STATE OF WASHINGTON
STATE BUILDING CODE COUNCIL

Title: Appendix XX: Single Exit Provisions for Multifamily up to 6 stories
(e.g: Footings for wood foundations)

Proponent: Washington State Building Code Council
Title: Single Exit Multiplex Housing TAG
Date: November 4, 2025

Figure XX102.2 – Single Exit Stairway Serving 5 stories of R-2 Apartments in a 6-story Building

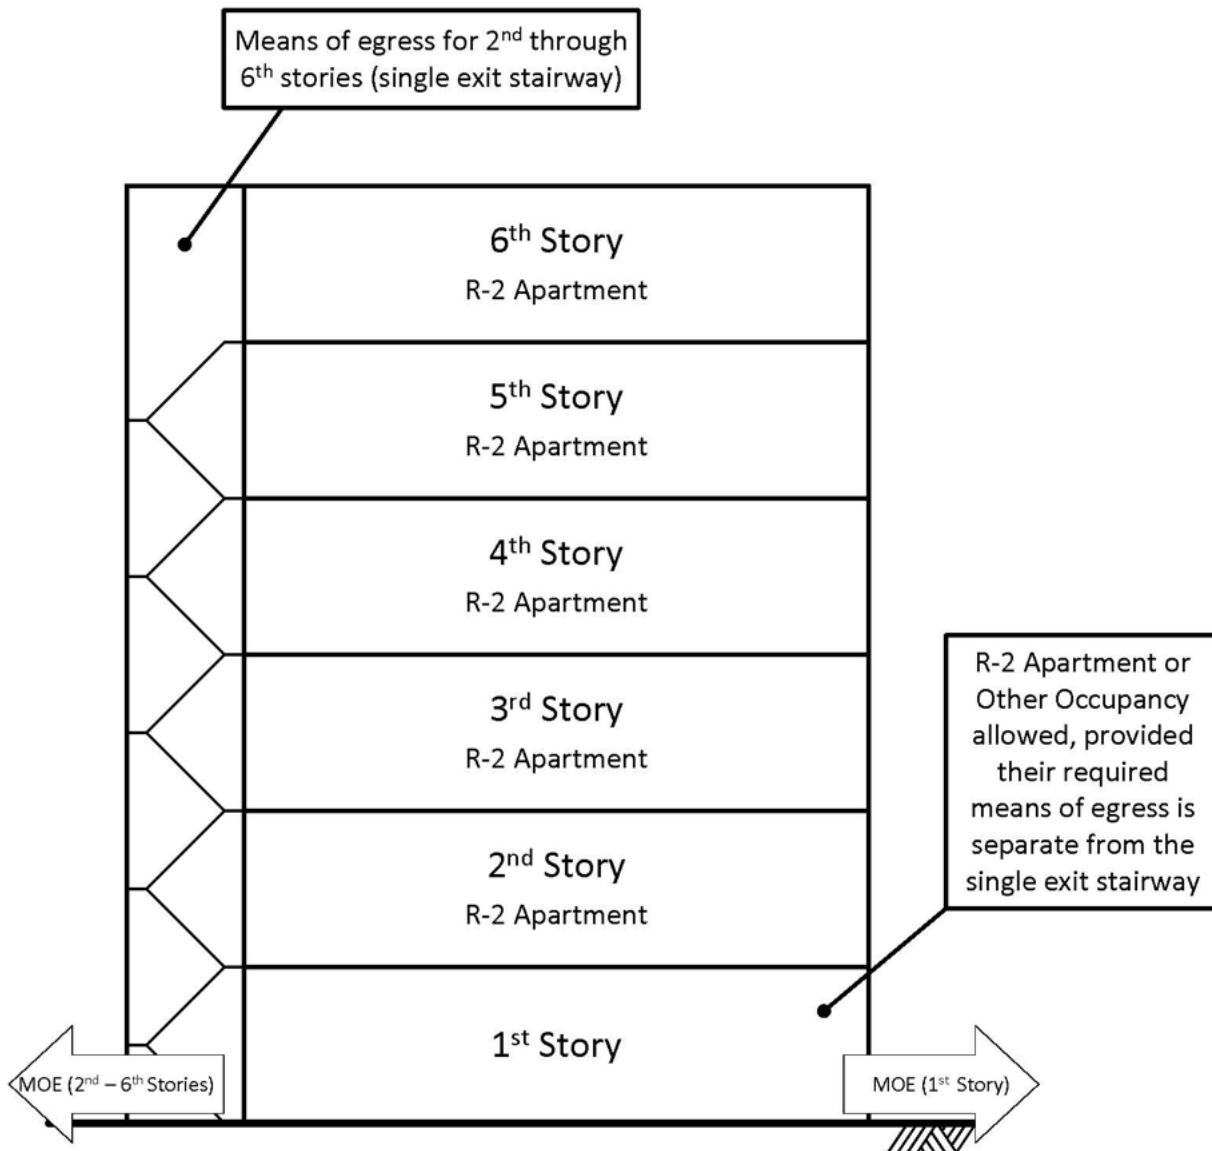
XX102.2 Single exit in Group R-2 apartment houses. In addition to the *means of egress* requirements of Chapter 10, not more than 5 stories of Group R-2 Apartment Houses are permitted to be served by a single exit under the following conditions:

1. The building has not more than six stories above grade plane.
2. **USER NOTE:** The 5-story limitation in Section XX102.2 does not prohibit an R-2 apartment occupancy from being located on the first story of a 6-story building. For a 6-story building with a single exit stairway, R-2 apartments or other occupancies are permitted on the first story (subject to other requirements in this code), provided that the required means of egress for the occupancies on the first story are separate from the single exit stairway. See Figure XX102.2. Other occupancies are permitted in the same building provided they comply with all the requirements of this code. Other occupancies shall not directly communicate with the Group R-2 occupancy portion of the building or with the single-exit stairway.
